**DOCUMENT 00 90 00
ADDENDUM**

ADDENDUM NO. [1] Date: September 29, 2020

**RE: WITC – RICE LAKE CAMPUS
HEAT PUMPS
1900 COLLEGE DRIVE
RICE LAKE, WI
HSR PROJECT NO. 20022-4**

**FROM: HSR Associates, Inc
100 Milwaukee Street
La Crosse, WI 54603
(608) 784-1830**

11. Reference Drawings M1, M2 and M3 (attached hereto)

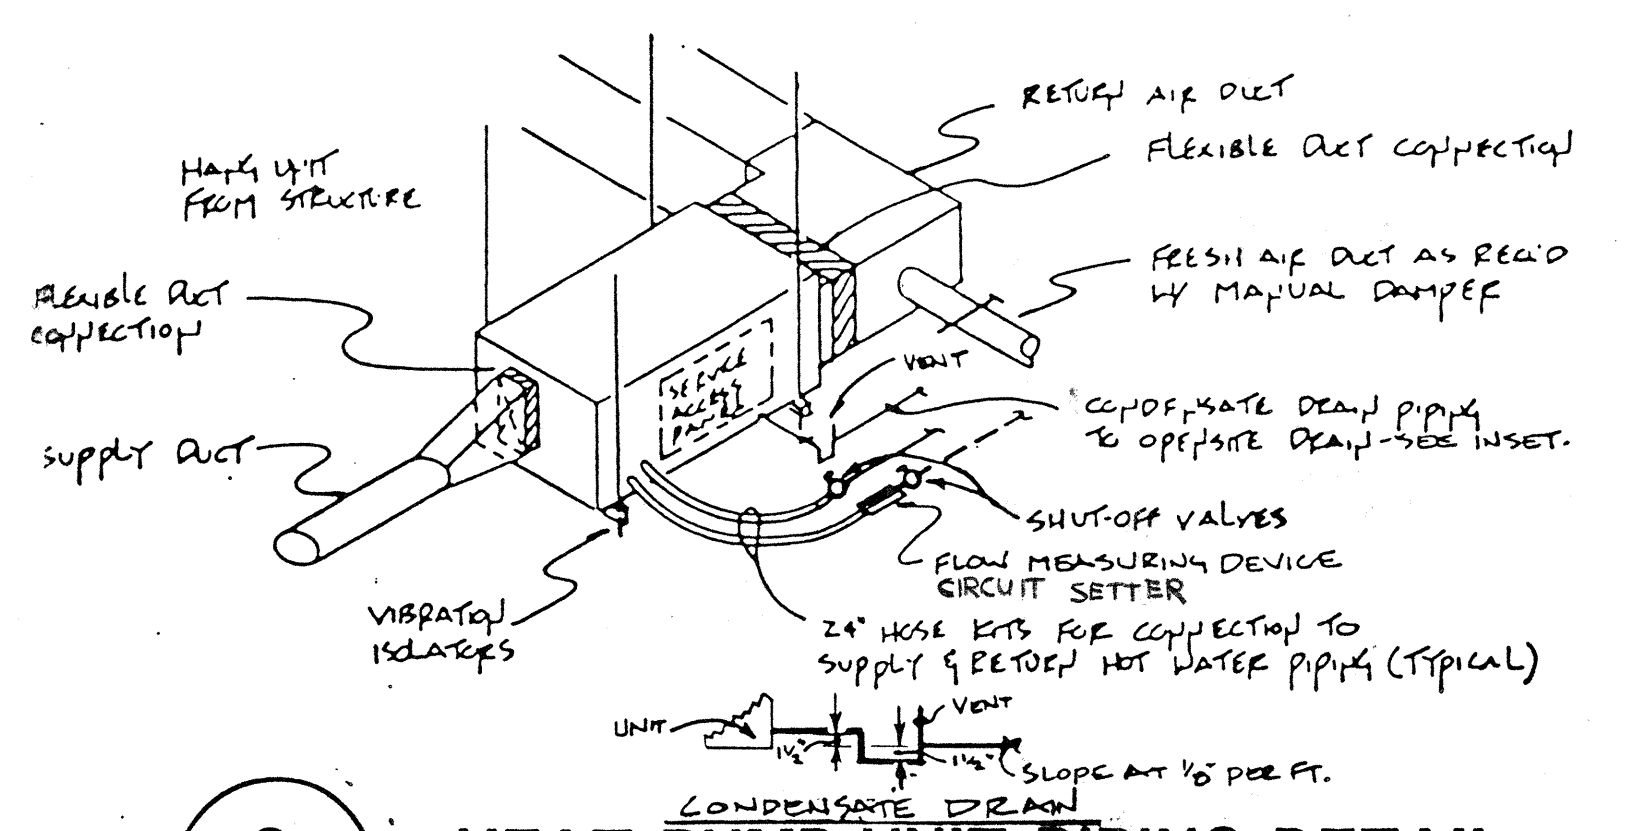
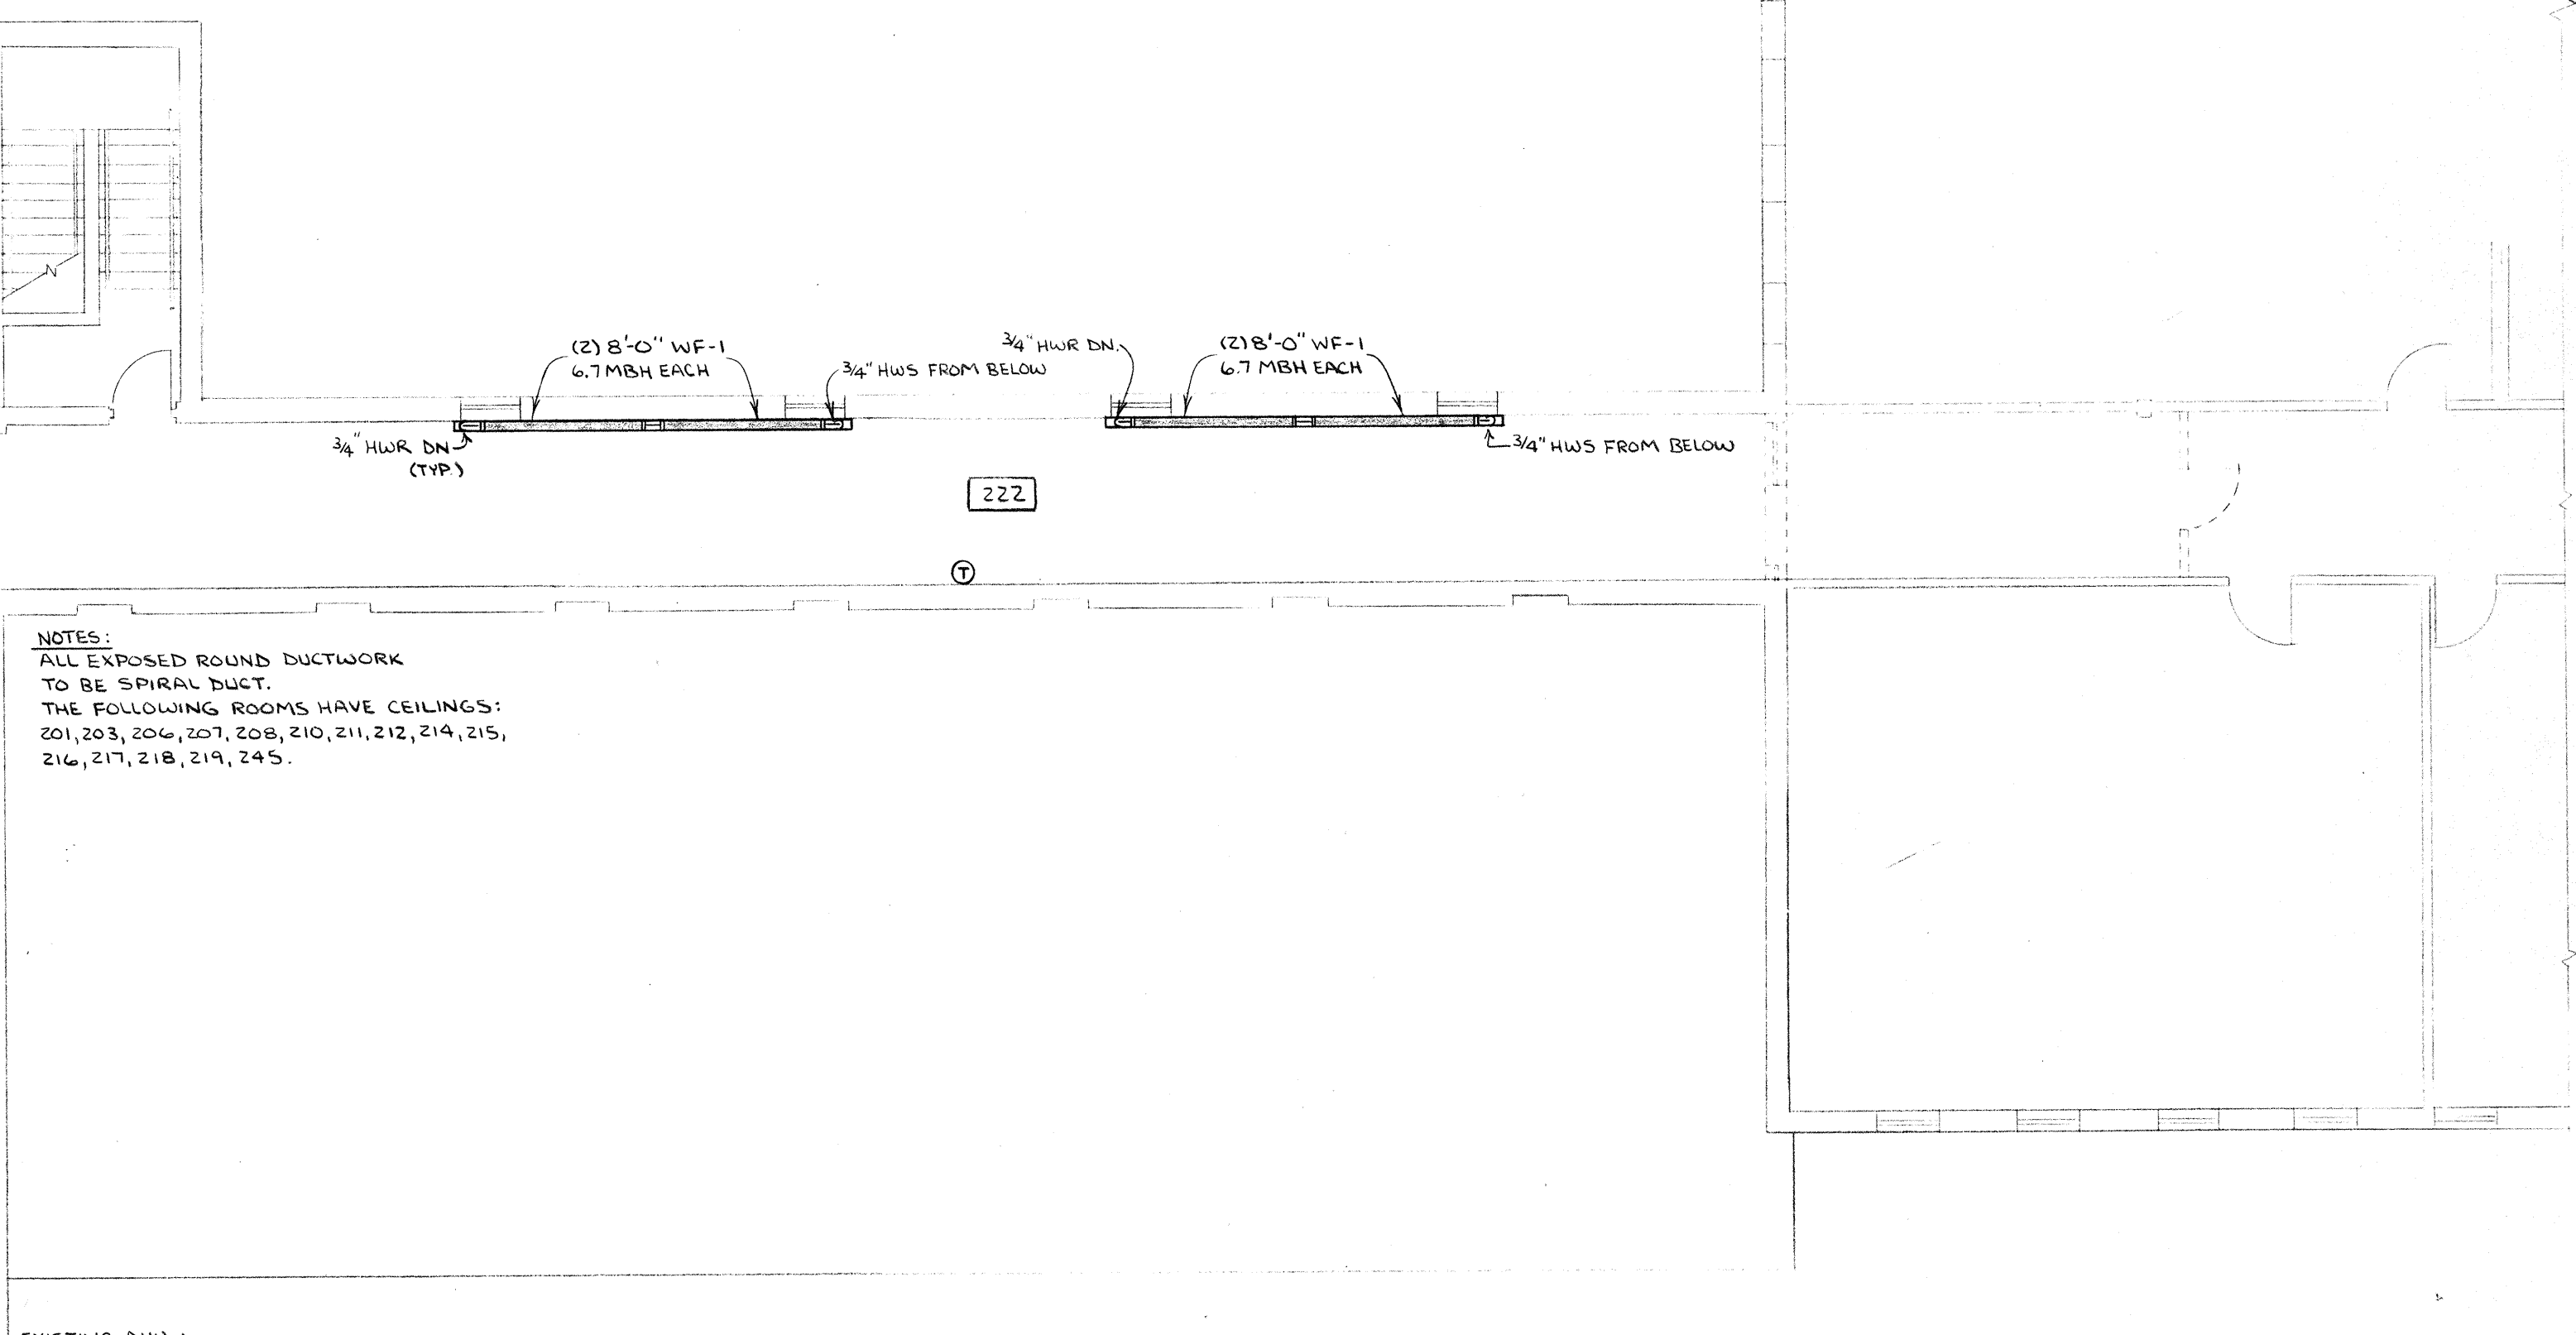
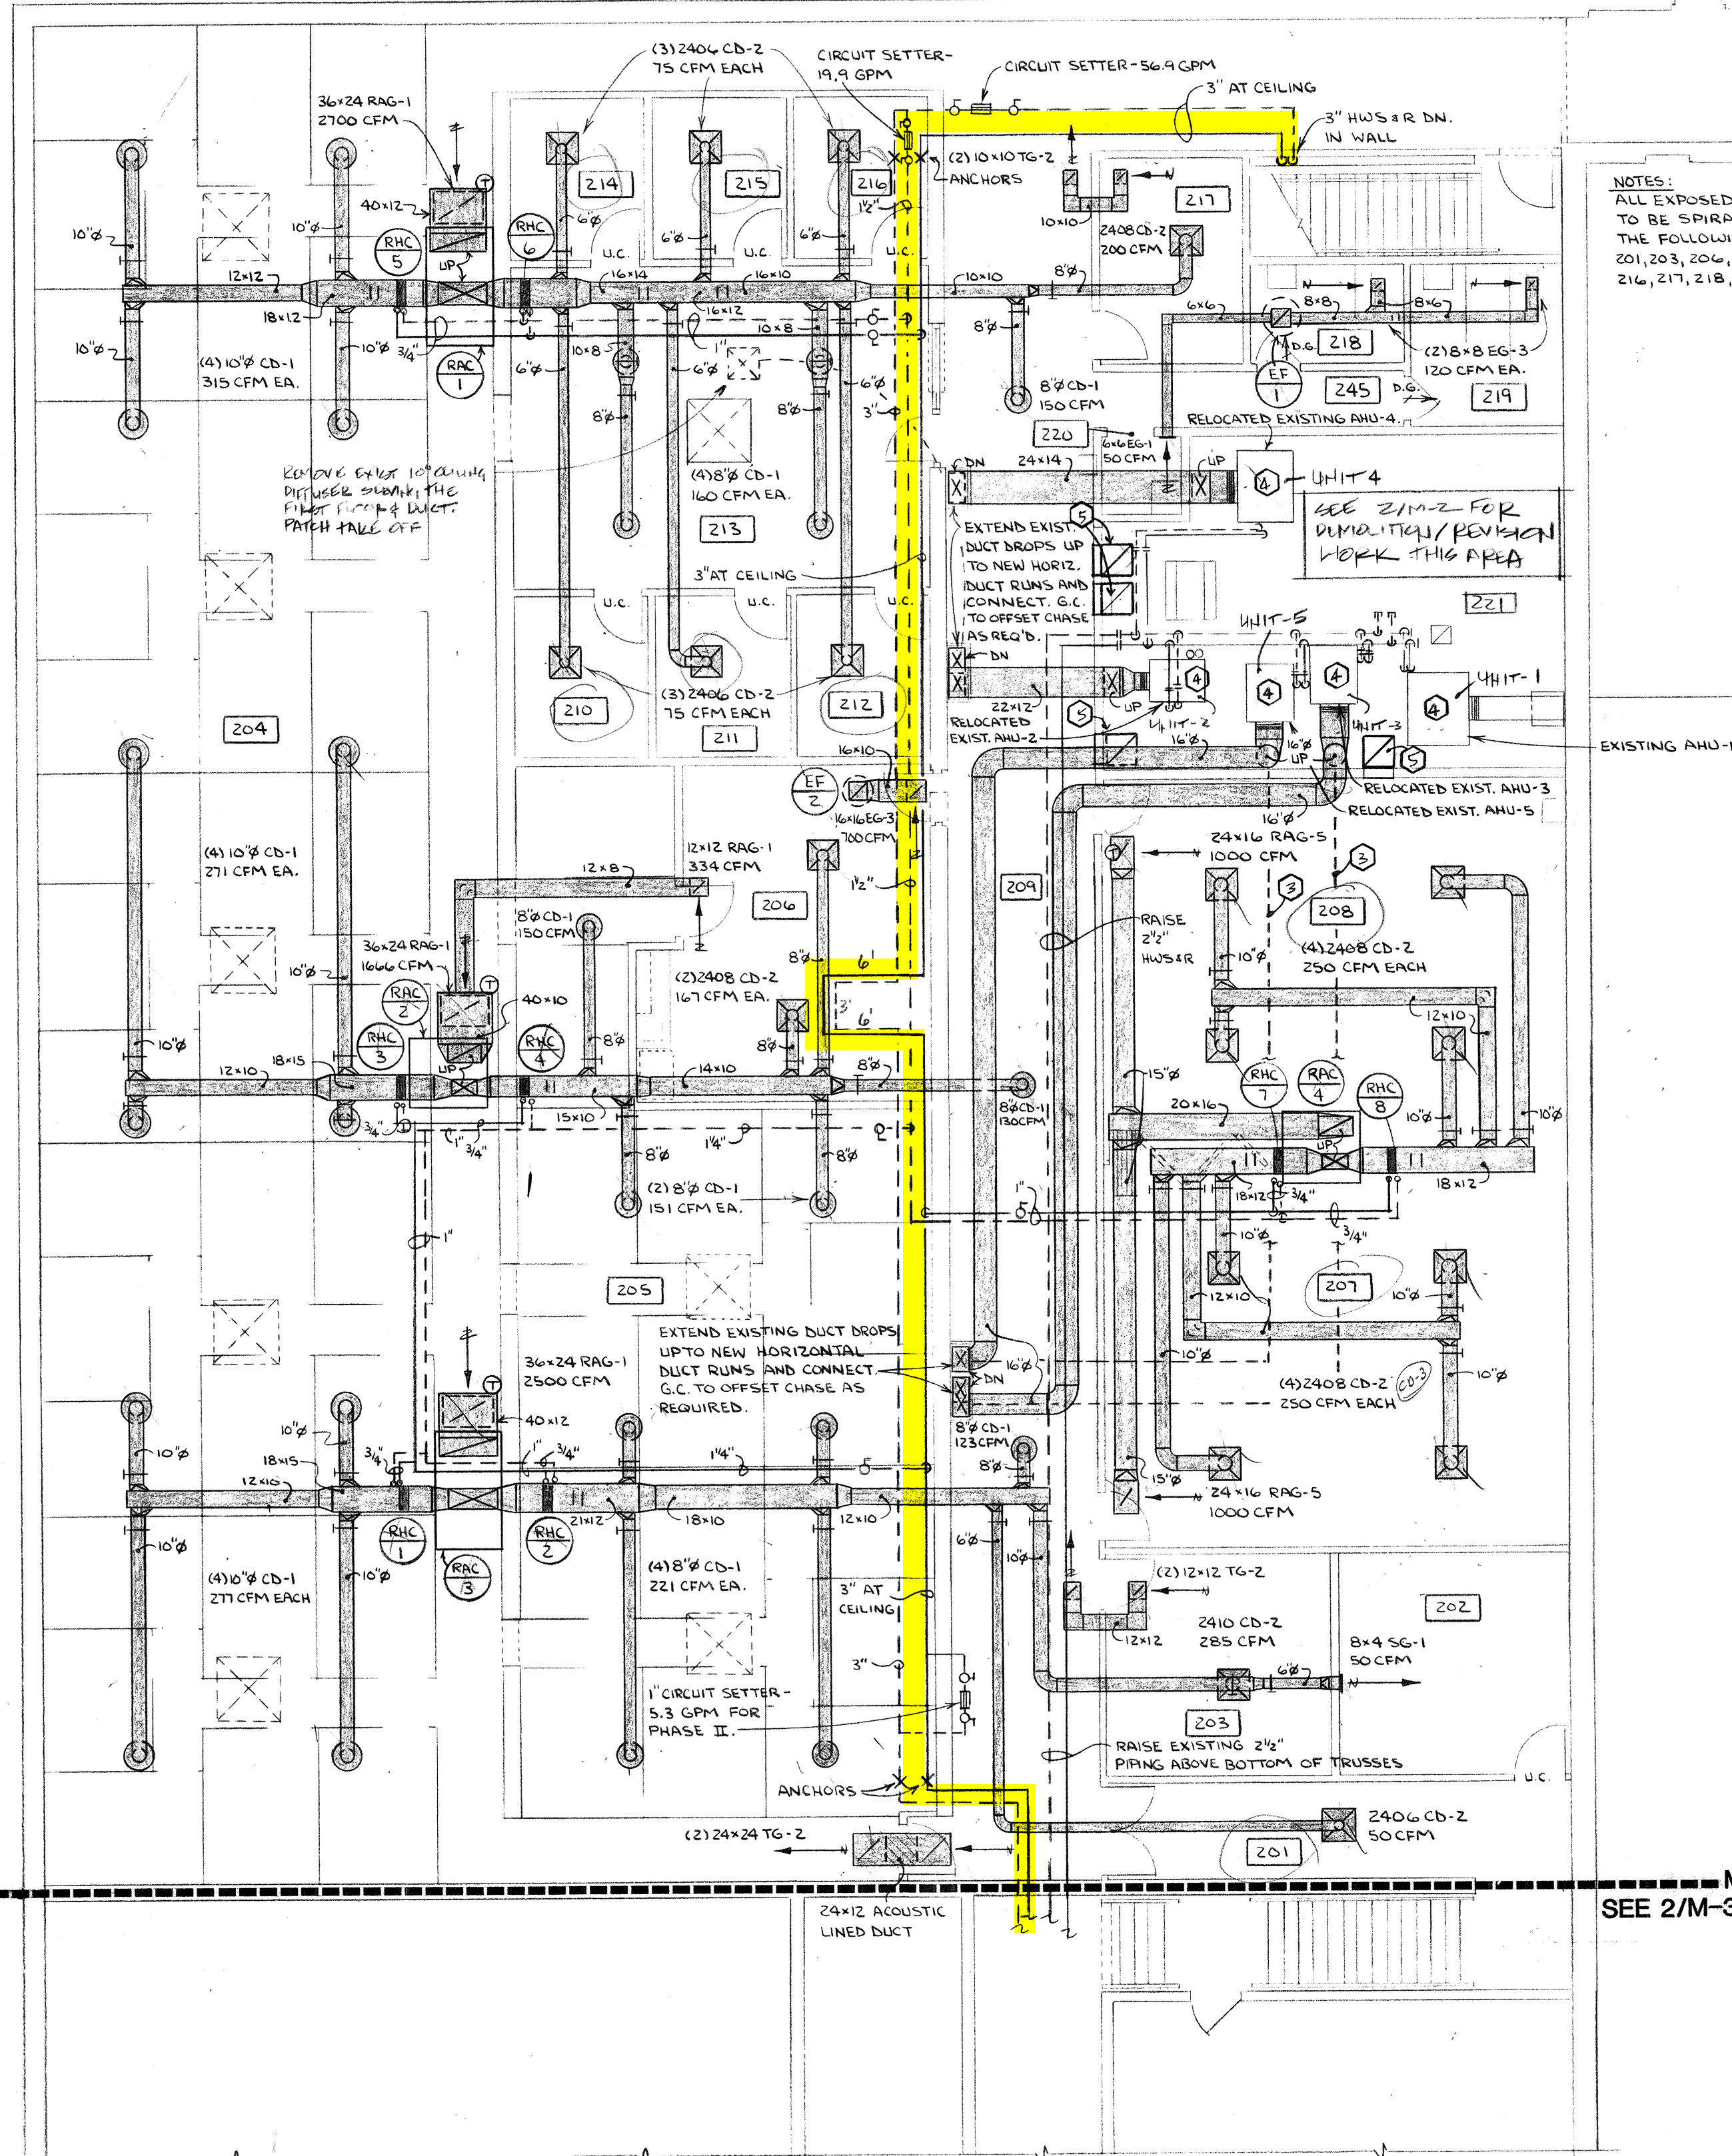
- a. Clarification: Reference attached supplemental record drawings for existing hot water heating pipe size and route between construction area and boiler room. Main shut-off valves do not exist between the project area and the boiler room. Contractor to provide necessary means and methods for connection of new to existing pipes. Add valves at new to existing connection. Coordinate all system and equipment shut downs with owner representative.
